# ANN ARBOR HISTORIC DISTRICT COMMISSION

## Staff Report

**ADDRESS:** 317 S Division Street Application Number HDC25-0115

**DISTRICT:** East William Historic District

**SITE PLAN**

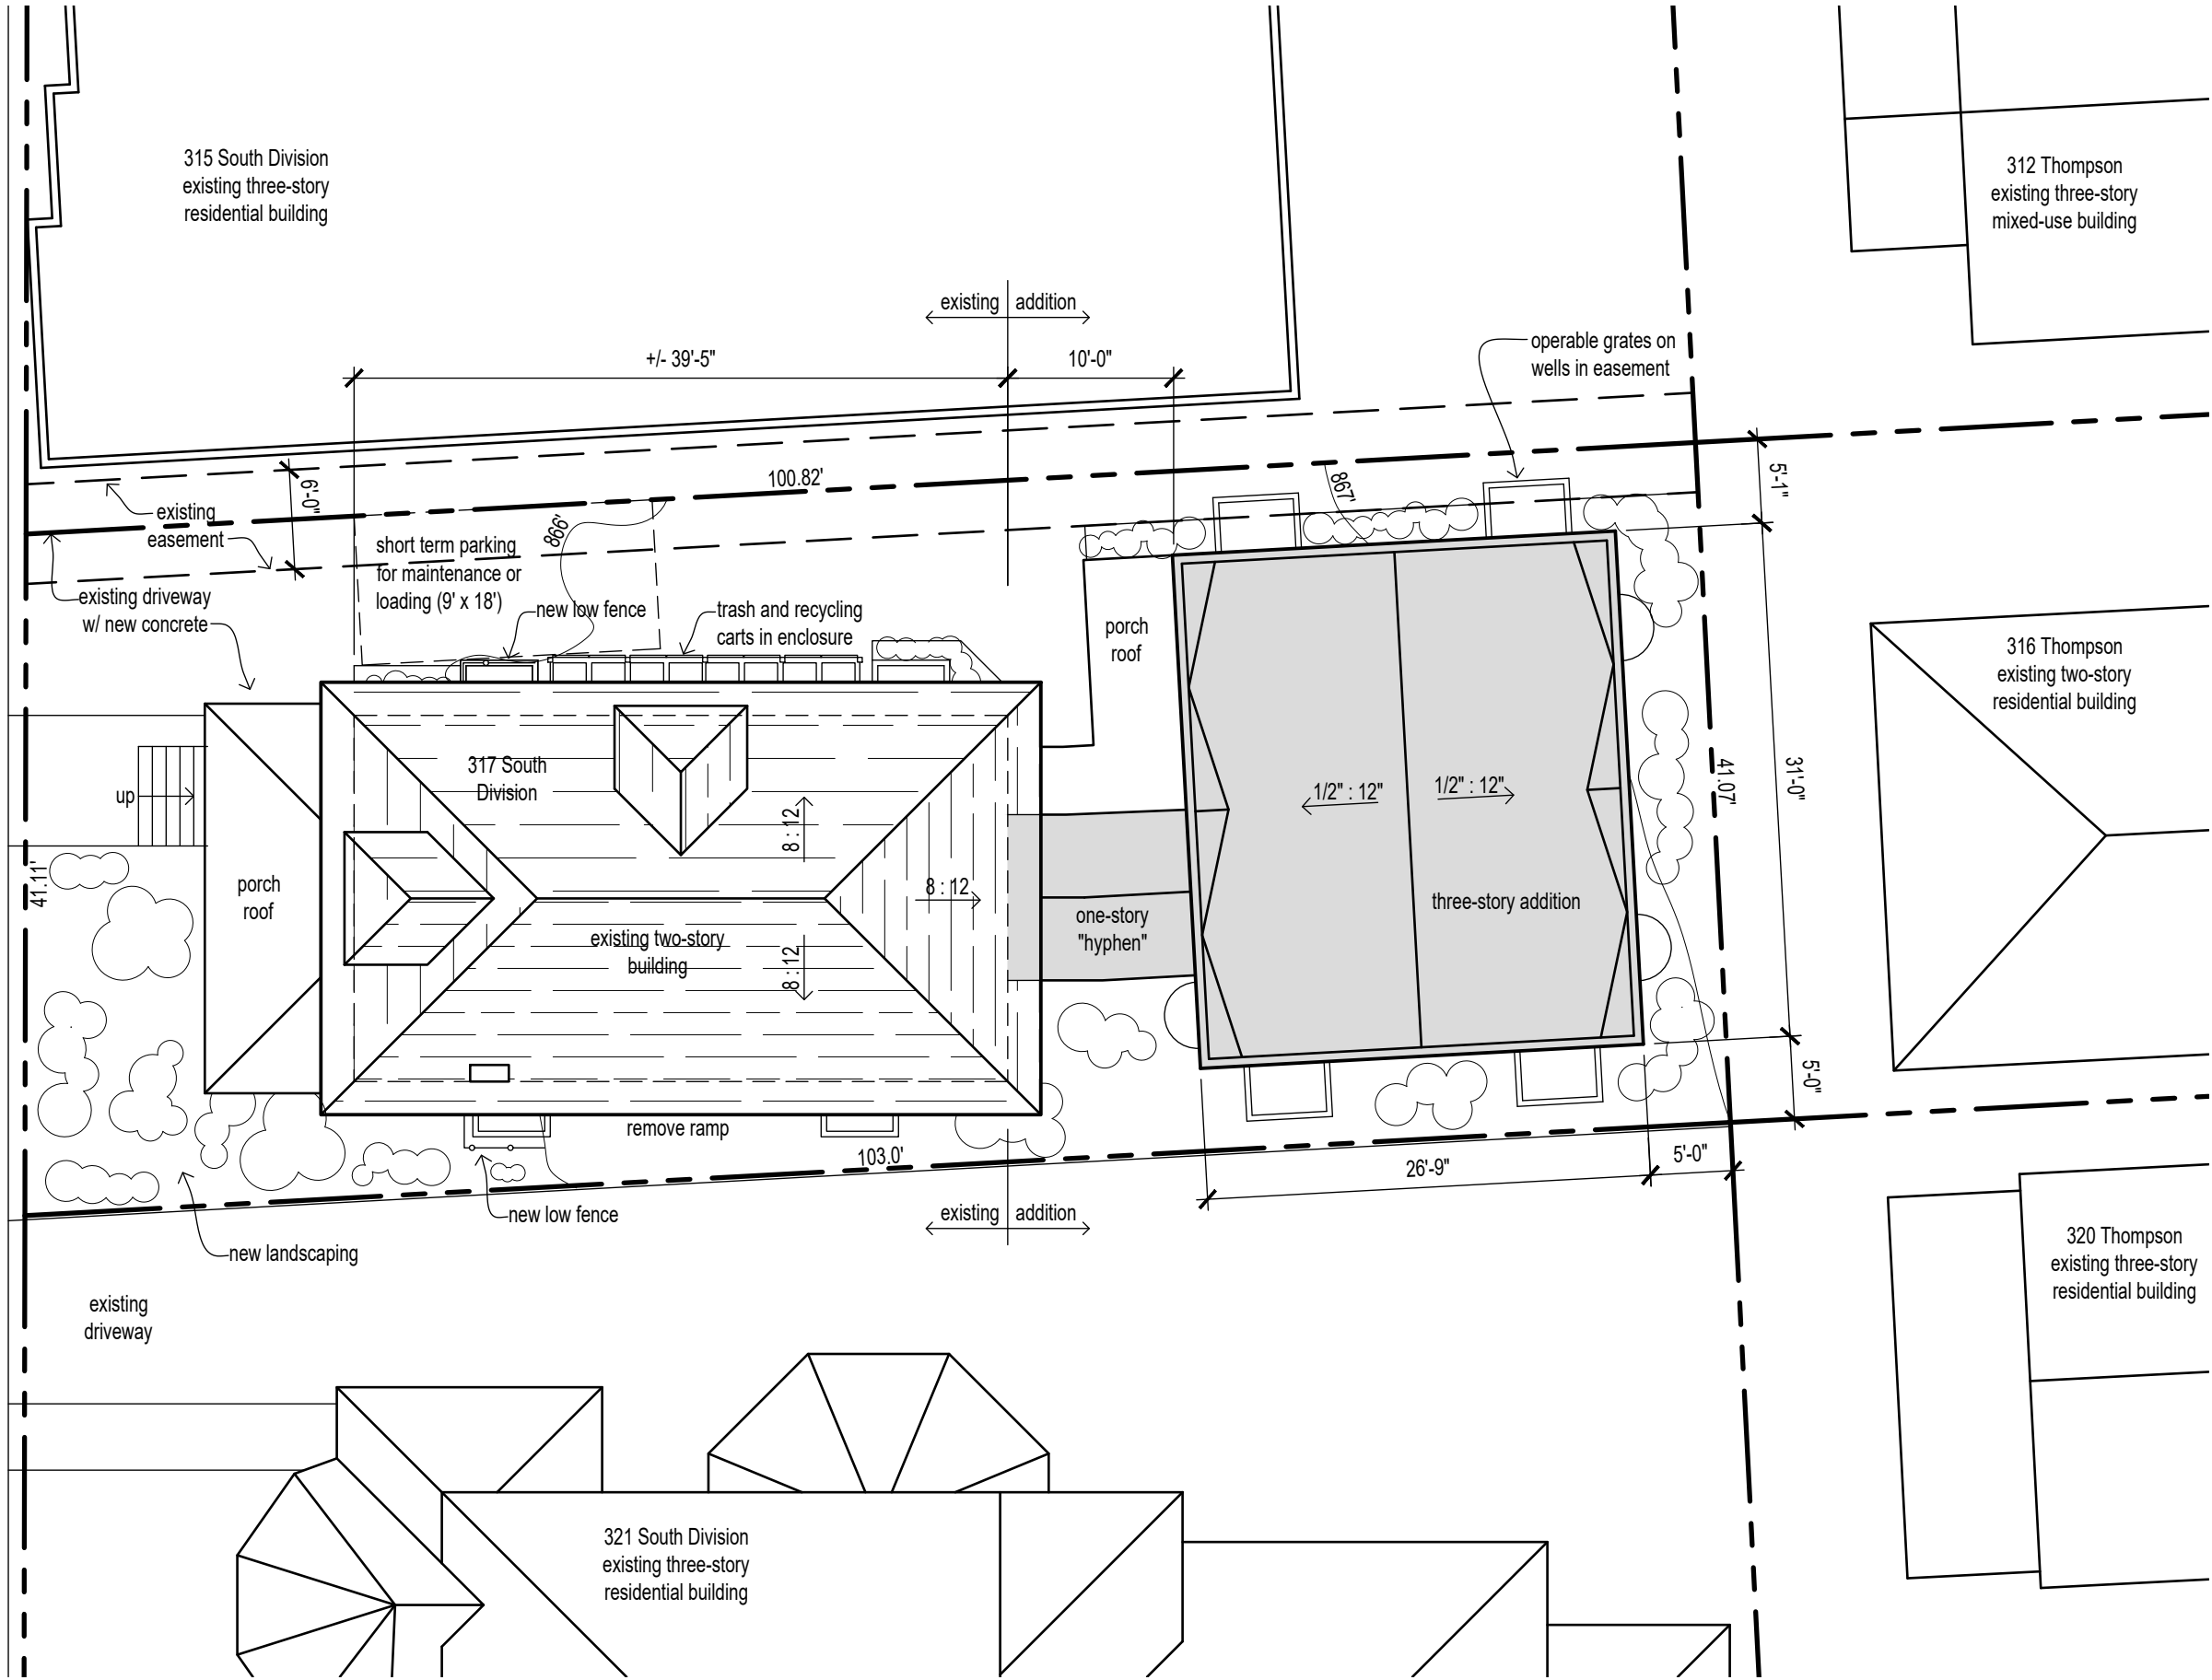
2. Egress Windows. Four basement egress windows are proposed to be added: two on the north and two on the south elevation. The ones near the back of the house are appropriate. The two near the front of the house include a 4' fence and landscaping as screening. Their proximity to the front elevation requires HDC approval, instead of staff.

New landscaping is noted on three sides of the building, without more specifics. It should be noted that these areas don't have to have lawn, but that lava rock, pea gravel, or similar non-decomposable materials are not appropriate for use in landscape areas.

8. The application states that the existing footprint is 879 sf and the existing floor area is 1,749 sf. The floor area of the addition is 2,598 sf, an increase of 148%. The footprint of the addition is 940 sf, an increase of 107%. As stated above, staff believes the design guidelines for residential additions should not be strictly applied here because of the circumstances of this particular lot and block. The house is flanked on both sides by much larger, deeper buildings. This is not a block with traditional back yards. Most of the lots have either parking in the back or are built out to the rear lot line. The lots on Thompson Street, behind 317 S Division, are very shallow with minimal backyards.

1 WEST ELEVATION (FRONT)  
1/8" = 1'-0"

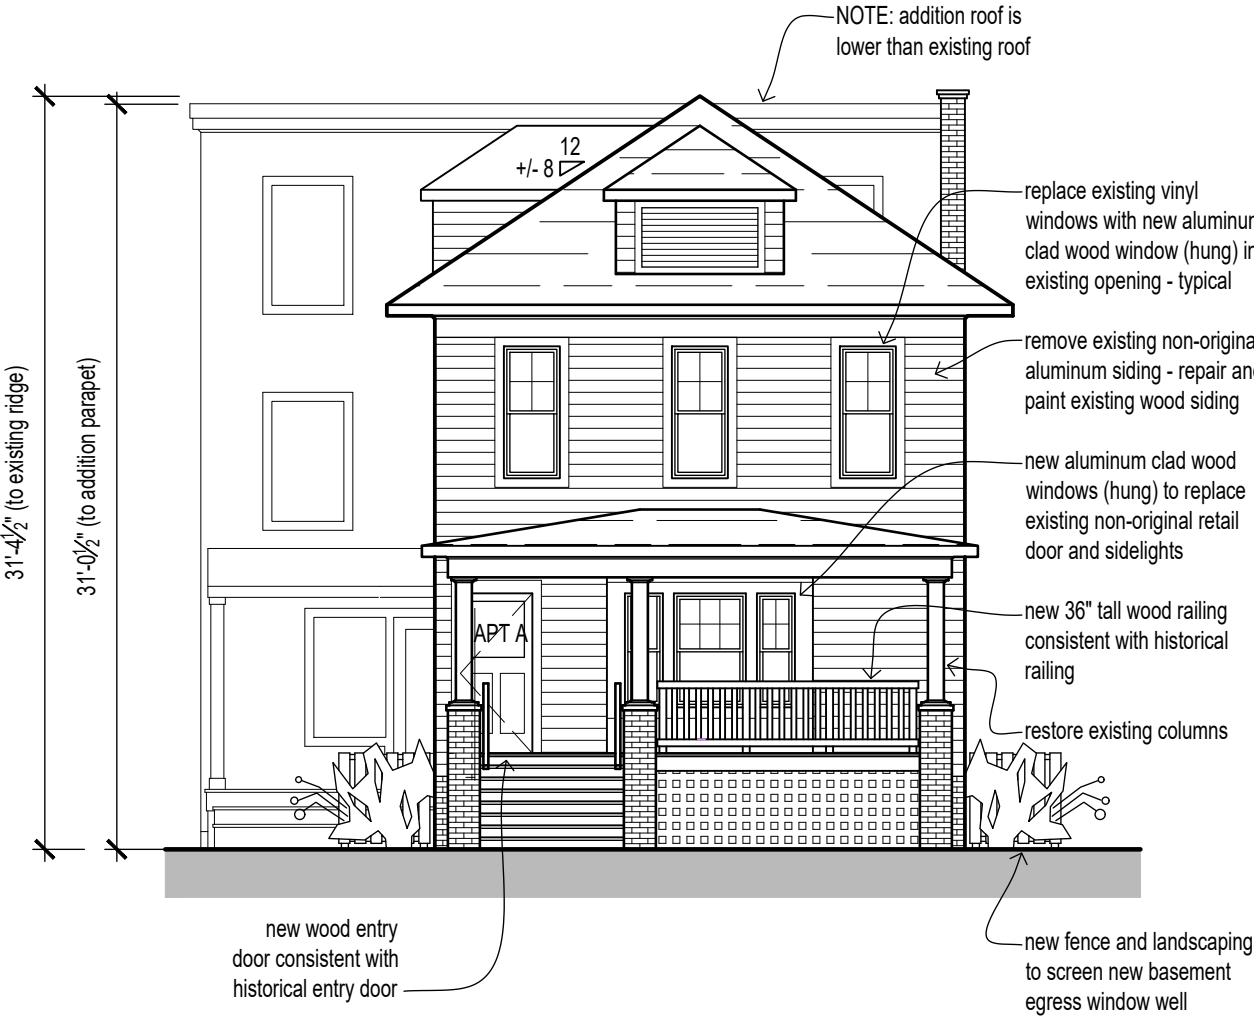
4. Front Porch. The restoration proposal for the front porch is generally appropriate. Staff would prefer to see a lower guardrail that is closer to the height of the 1913 one, and which uses additional horizontal "booster rails" (typically painted black to make them recede) on top to make up the code-required height. [[This website](#) is a bit silly but has photos of good built examples near the bottom of the page.] Porch skirting is not called out but is shown as a square lattice instead of diamond, so staff assumes it will be replaced with new wood square lattice. Removing the business front door and restoring the front bay window is highly appropriate.

**NORTH ELEVATION (SIDE)**

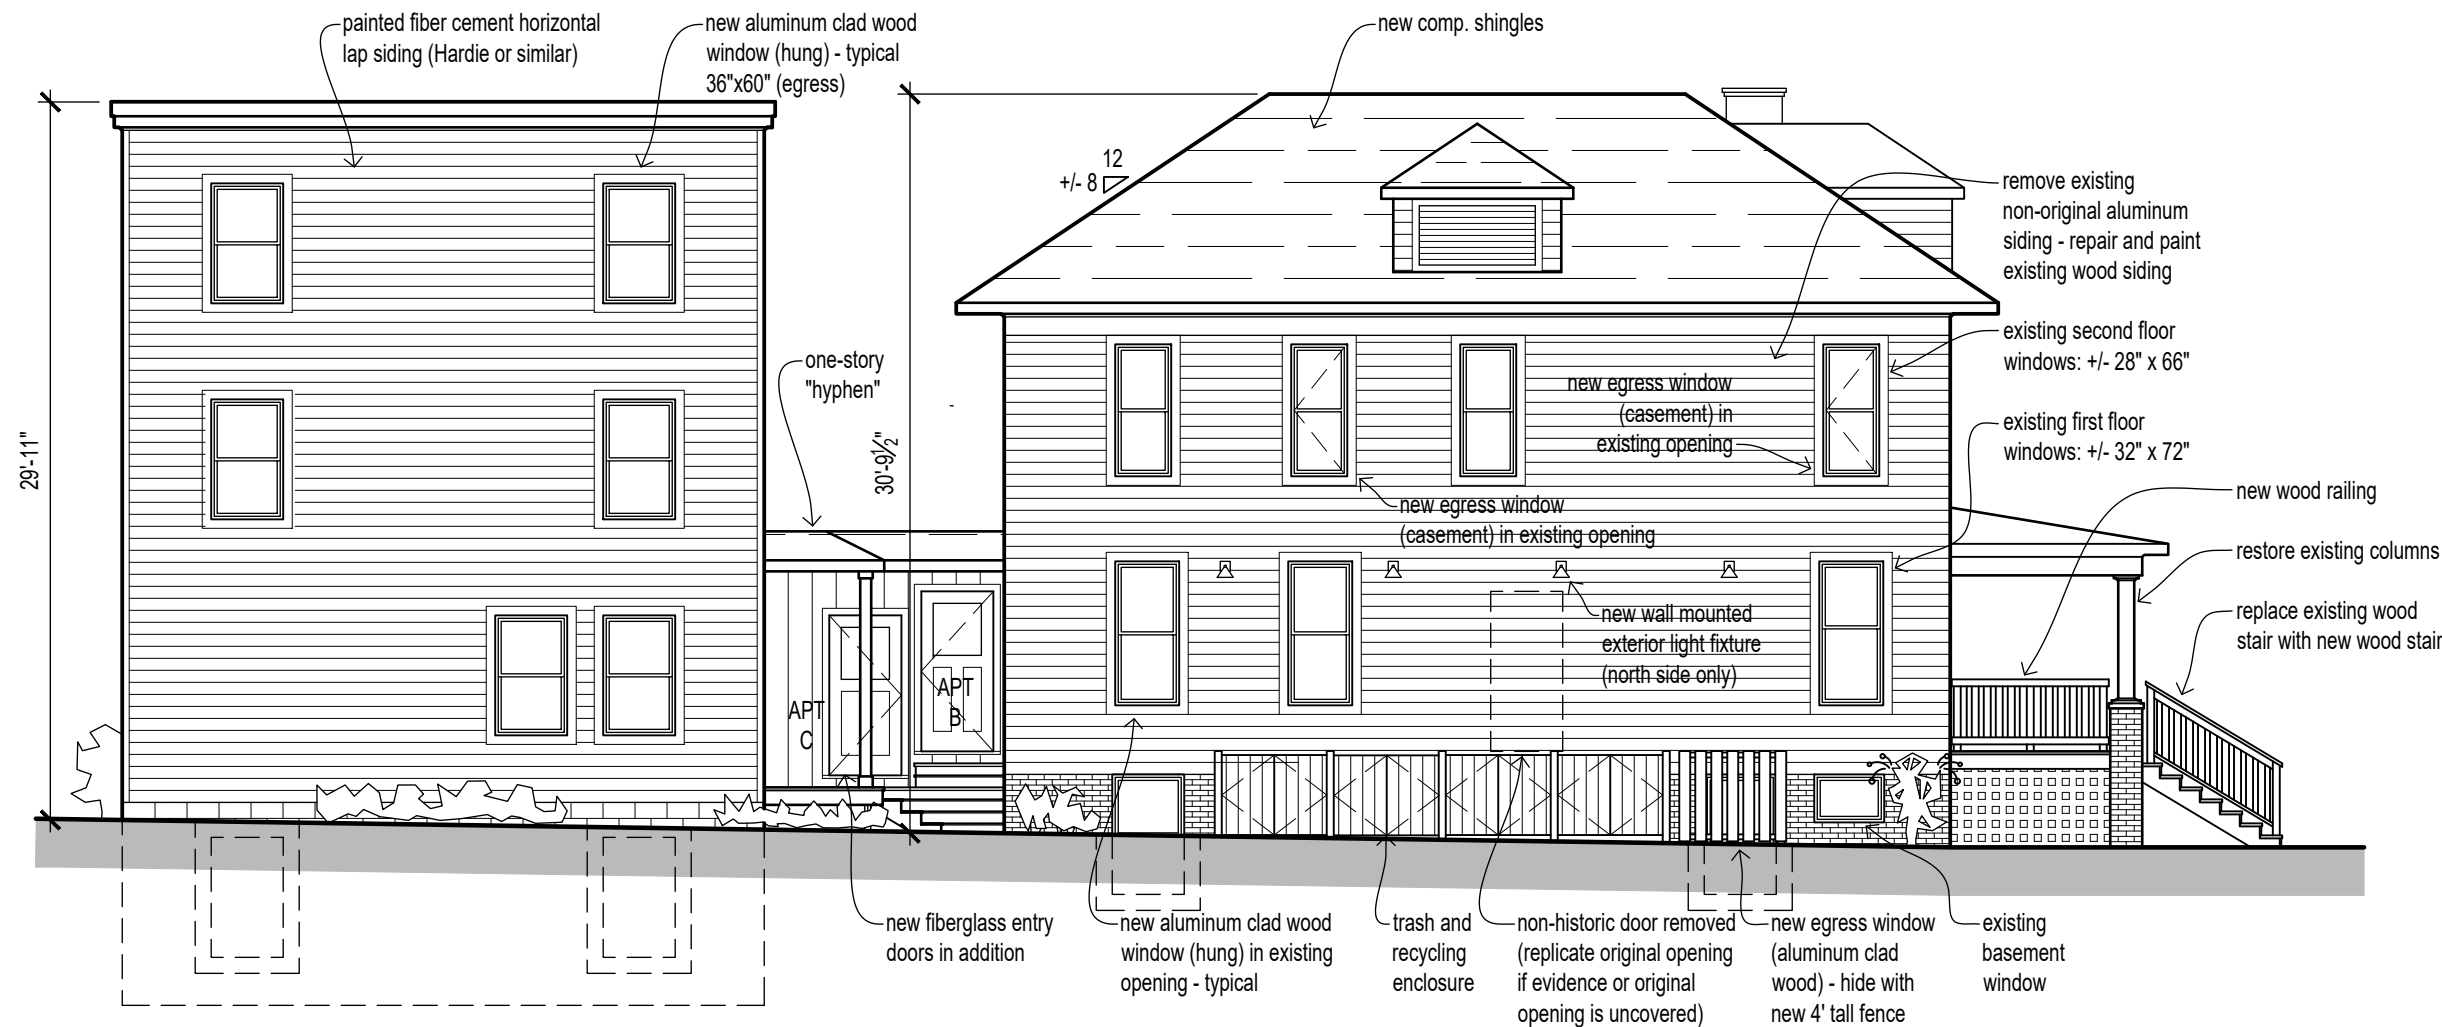
3. North Elevation. A door with steps leading up to it is present on the north elevation. The architect reported that it did not correspond to basement steps on the interior, so it is unlikely that there was originally a door here. The drawings say that if a historic opening is found (once the aluminum siding is removed and/or the interior studs are exposed), it will be restored and a door installed. The applicants can work with staff if that is the case. If there is no historic opening found, the opening will be infilled to match the underlying siding.

The trash enclosure is appreciated. There will be a large number of trash and recycling carts and keeping them contained and out of sight is appropriate. The enclosure will be 4ft tall. Materials are not noted on the drawings.

The four new wall-mounted lights along the north elevation are on a wall plane that would

not have traditionally had lights mounted on it. (There is one modern one there now.) This is an urban site with pedestrian traffic from both this site and the large apartment building next door. Staff finds the lights acceptable and notes that if approved they must meet the city's outdoor lighting requirements in Chapter 55 of City Code.
